MODIFICATION RECOMMENDED –
CORRECTS MANUFACTURING OR DESIGN DEFECTS

SN J6800A-07

S E R V I C E N O T E

J6800A Network Analyzer

Photo #2 Close up of mounting hole showing copper pulled down into hole.

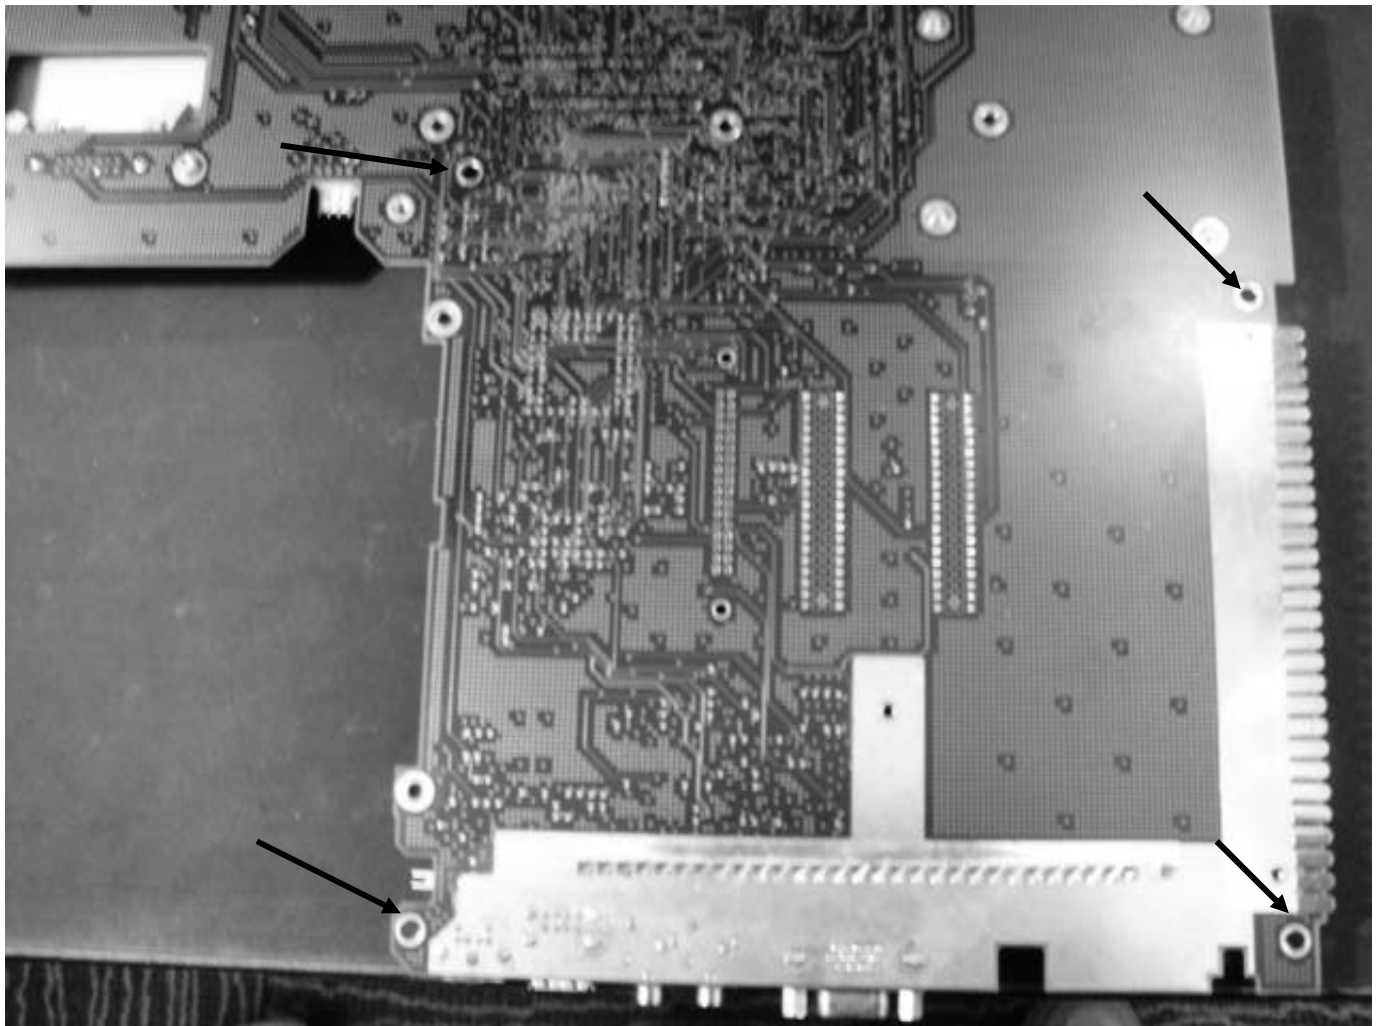
A poor mechanical design in the method used to attach the acquisition system and the CPU carrier card to the bottom chassis of the J6800A can cause multiple failure modes. The most obvious is cold operation seems normal, however as the unit warms up the operation of the acquisition system starts to fail for no apparent reason.

The CPU carrier card has 4 mounting holes that are used to hold the acquisition cards to the chassis. (See photo #1) After some extended period of time, the threads on these screws cuts through the plating of the hole and wears away the PCB material, exposing the copper inner-layers. (See photo #2) These exposed copper layers can short 3.3v or 5.0v to ground. This causes excessive current draw, stressing the power supply and often scorching the Host I/O power connector itself. (See photo #3)

Replace all damaged parts, re-assemble unit using the washers(3050-2187) and test per J6800A service manual.

Use washers (3050-2187) with long mounting screws when re-assembling.
